## HUNTER'S COVE SUBDIVISION, UNIT TWO, PHASE TWO

APPLICATION NUMBER 10 DATE June 15, 2006  
APPLICANT Hunter's Cove Subdivision, Unit Two, Phase Two  
REQUEST Subdivision

# SUBDIVISION PLAT

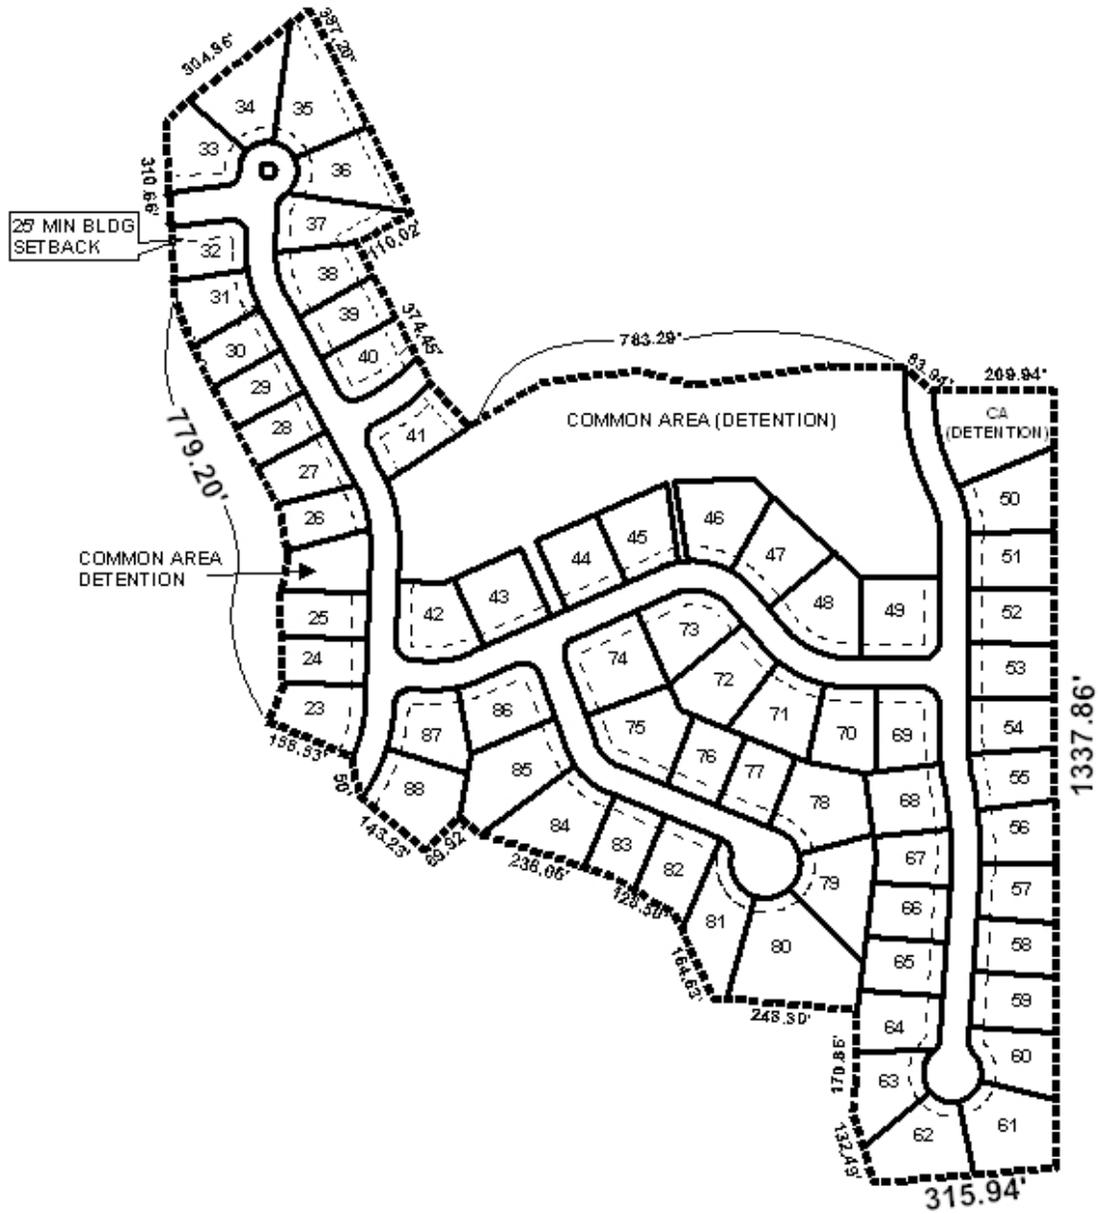
Common areas are depicted and labeled on the preliminary plat, as is a note stating that maintenance of any common areas will be the responsibility of the development's property owners association: this note should also appear on the final plat, if approved.

The "General Notes" portion of the preliminary plat identifies various utility and drainage easements, which should also be graphically depicted on the drawing.

This site is located in Mobile County, thus a note should be placed on the Final Plat stating that any lots which are developed commercially and adjoin residentially developed property must provide a buffer, in compliance with Section V.A.7. of the Subdivision Regulations.

Based upon the preceding, the plat is recommended for Tentative Approval, subject to the following conditions: 1) retaining of common area labeling and notes; 2) graphic depiction of all drainage and utility easements referenced in the "General Notes" section; and 3) placement of a note on the Final Plat stating that any lots which are developed commercially and adjoin residentially developed property must provide a buffer, in compliance with Section V.A.7. of the Subdivision Regulations.
